**CITY OF
PARRAMATTA**

Report to Sydney Central City Planning Panel

SWCCP Reference	2018SWC081 DA
DA No.	DA/469/2018
Date of Receipt	16 July 2018
Proposal	Construction of a place of worship building comprising a Grand Cathedral, public forecourt space, multipurpose hall and associated basement parking. The application is identified as Integrated Development for the purposes of the Water Management Act 2000. The determining authority is the Sydney Central City Planning Panel (SCCPP).
Street Address	163-165 George Street, PARRAMATTA
Property Description	Lot 1 DP 78716, Lot 1 DP 113513 & Lot 1 DP 650704
Applicant	The Hellenic Orthodox Community of Parramatta
Owner	The Hellenic Orthodox Community of Parramatta
Submissions	Two (2) submissions received
Conciliation Conference Held	Not Required
List of All Relevant s4.15(1)(a) Matters	<ul style="list-style-type: none">Environmental Planning and Assessment Act and RegulationsState Environmental Planning Policy No. 55State Environmental Planning Policy (Sydney Harbour Catchment) 2005State Environmental Planning Policy (Vegetation in Non-Rural Areas) 2017State Environmental Planning Policy (State and Regional Development) 2011State Environ

Figure 21: Height of Buildings Map – Sheet HOB_010 (Parramatta LEP 2011)

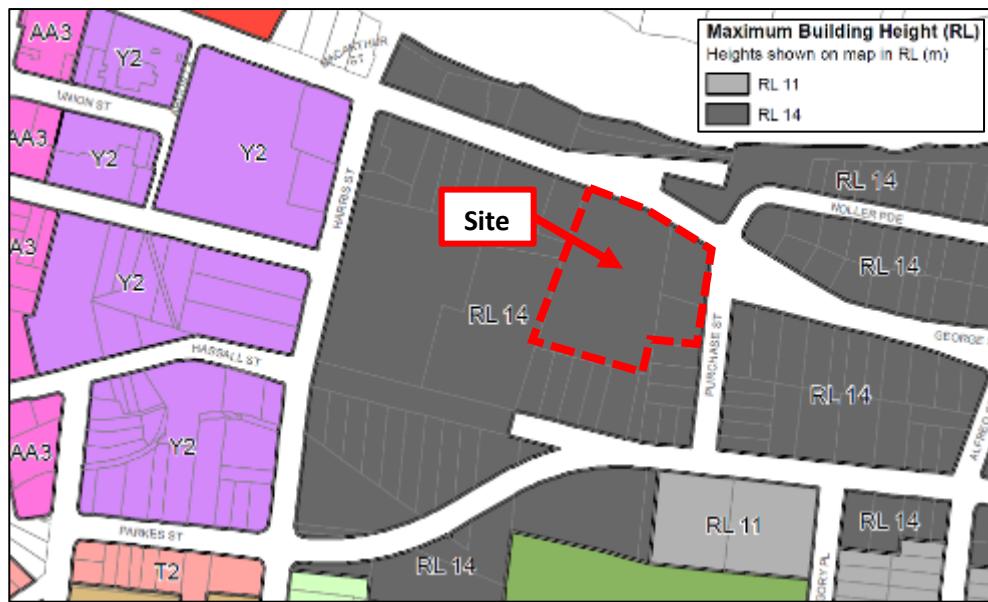
- a. **Building Height:** The application seeks to vary the height standards applicable to the site under Clause 4.3 of the Parramatta Local Environmental Plan 2011, from RL 14m to RL 34m (143% variation). The submitted Clause 4.6 request is not supported.

The standard/s Clause 4.3 of PLEP 2011 - Height of buildings – RL 14m (see Figure 21).

Figure 22. Extract of sectional drawing when viewed from the north and south elevations (longitudinal sections).

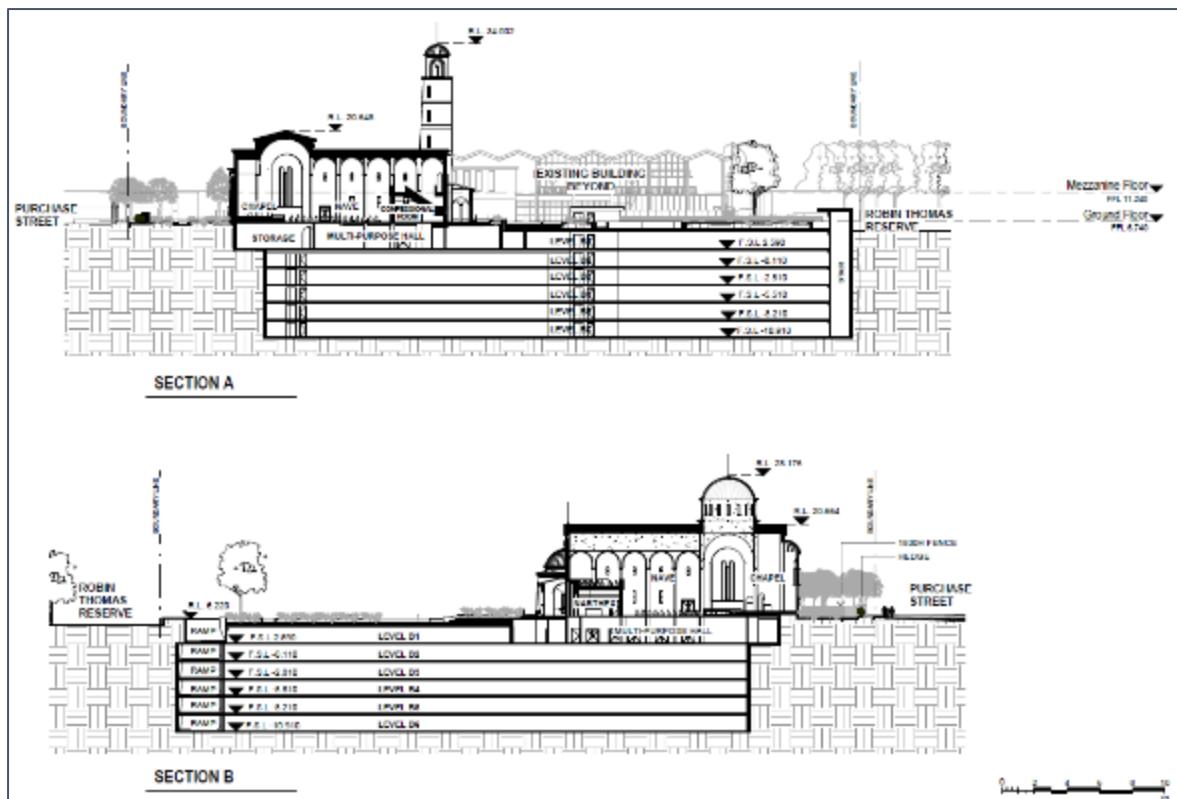
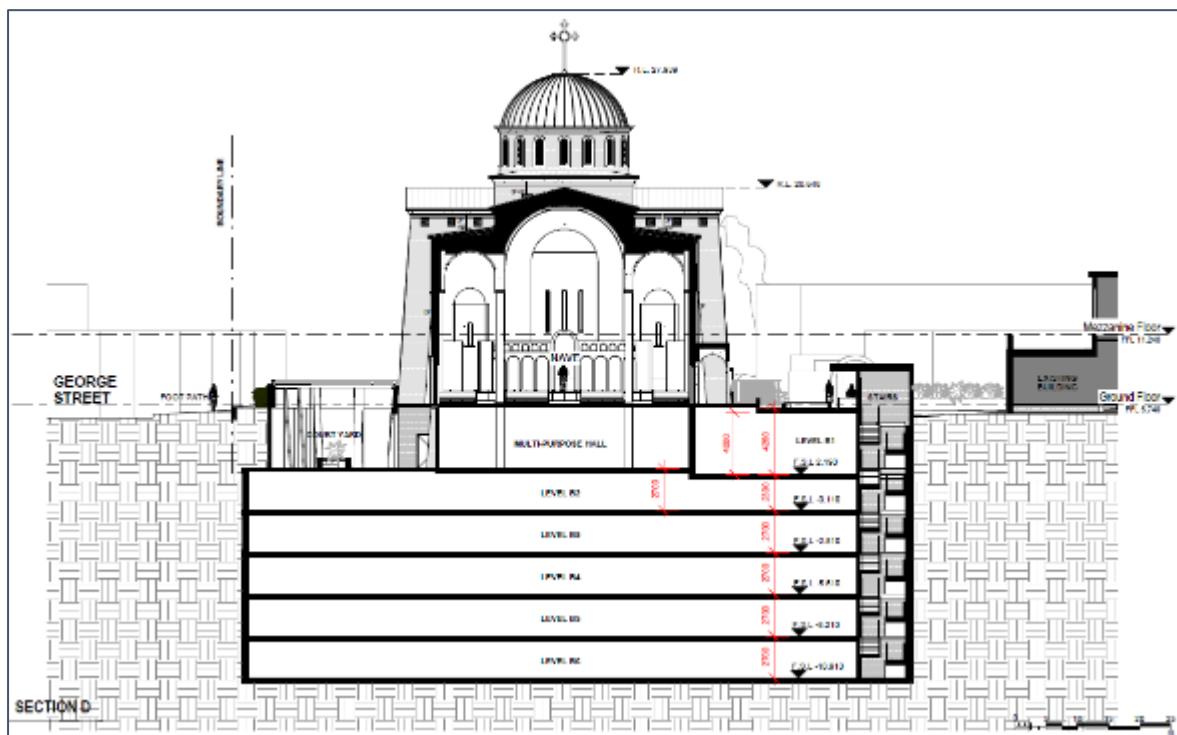
b) Bell tower, uppermost part of the proposal:

- Allowable = RL 14m
- Proposed = RL 34.002m
- Variation = 20.002m / 143%

This proposal has 2 x domes and 1 x bell tower that are not 'integrated' within the roof. Rather they act as dominant features of the building. They accentuate the place of public worship and provide a sense of identification for the congregation. They certainly do not 'integrate with the building composition and form'. Their very nature is to do the opposite. They are intended to be seen from a distance so that people can recognise this building. Their scale and size are not contributory to a roof feature. Instead they are stand-alone elements of the building and need to be considered as part of the overall height of the building.
